AMG SUBDIVISION

APPLICATION NUMBER 2 DATE June 6, 2019

DETAIL SITE PLAN

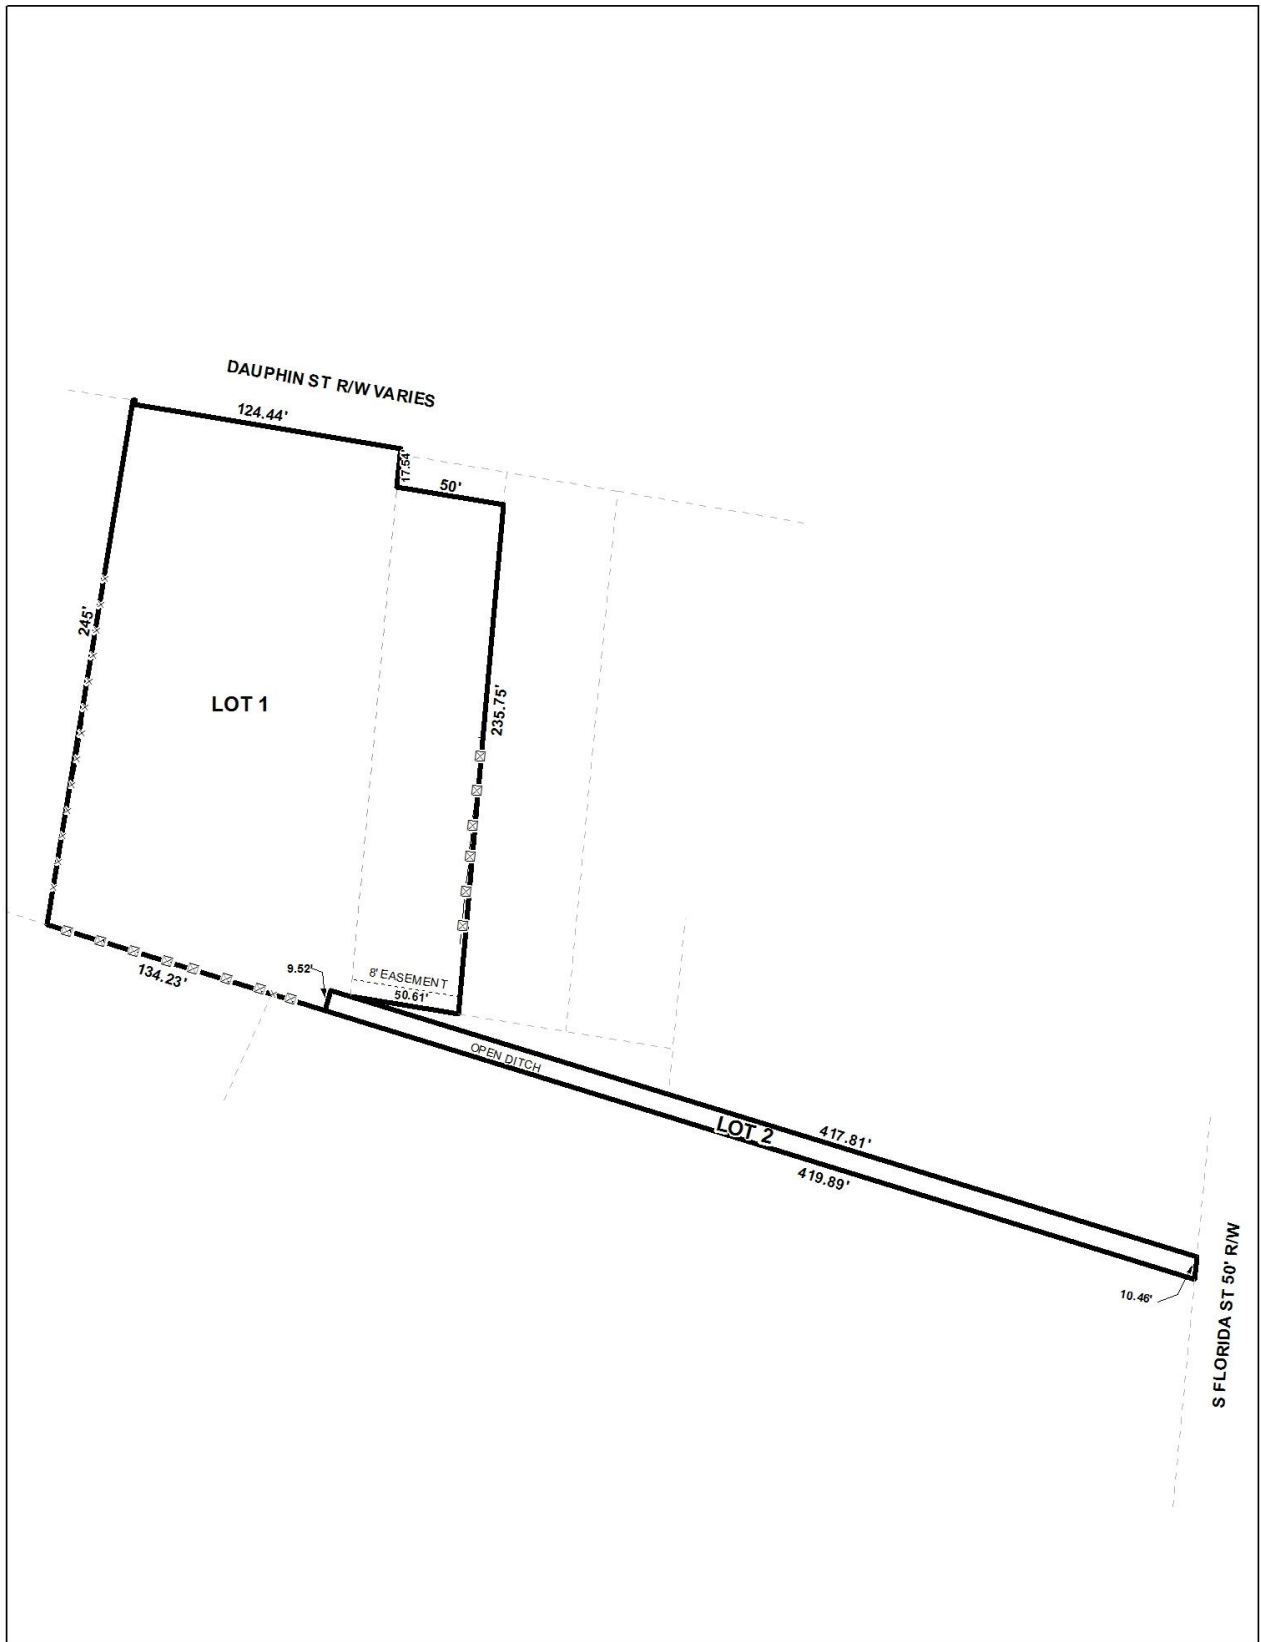
- B. Provide a vicinity map.
- C. It appears that LOT 2 contains existing drainage system that will not allow any construction to take place.
- D. Provide a detail of the boundary located at the NW corner of LOT 1.

- E. Review and revise the written legal description and boundary labels that do not match.
- F. Clarify the reference to NOTE 12.
- G. Note No. 8 indicates that NO easement or title search was done. You are required to indicate all existing drainage easements.

The proposed lots front Dauphin Street and South Florida Street. Dauphin Street is a Major Street on the Major Street Plan; however, there is no requirement for additional right-of-way. The preliminary plan does not provide the right of way width to Dauphin Street. The preliminary plat illustrates a compliant 50' right-of-way width for Florida Street and, if approved, should be retained on the Final Plat.

A 25-foot minimum building setback is required for both street frontages. Minimum building setbacks are not illustrated on the preliminary plat. The Final plat should be revised to provide a 25' minimum building setback along both street frontages, if approved.

The proposed Lot 1 exceeds the 7,200 square foot minimum lot size requirement for lots served by public water and sanitary sewer systems. The preliminary plat provides the lot sizes in square feet and acres. If approved, the lot size information should be retained on the Final Plat. It should be noted that the proposed Lot 2 does not meet lot size requirements or lot width requirements, and exceeds the maximum width to depth ratio. Furthermore, Lot 2 is illustrated as an open ditch with piping. As proposed, Lot 2 is an undevelopable piece of property, and should either be incorporated into Lot 1, changed into a common area, or a note should be placed on the plat stating that no construction is allowed on Lot 2 that is not associated with the existing drainage facilities.

- 1) Labeling of the minimum existing right-of-way of Dauphin Street;
- 2) Retention of the 50' right-of-way width to South Florida Street;
- 3) Provision of a 25' minimum building setback line along both street frontages;
- 4) Retention of lot size information in both square feet and acres;
- 5) Revision of Lot 2 to either be a Common Area, to be incorporated into Lot 1, or placement of a note on the Final Plat stating that no construction is allowed on Lot 2 that is not associated with the existing drainage facilities;
- 6) If Lot 2 is made into a Common Area, placement of a note stating that maintenance is the responsibility of the property owners and not the City of Mobile;
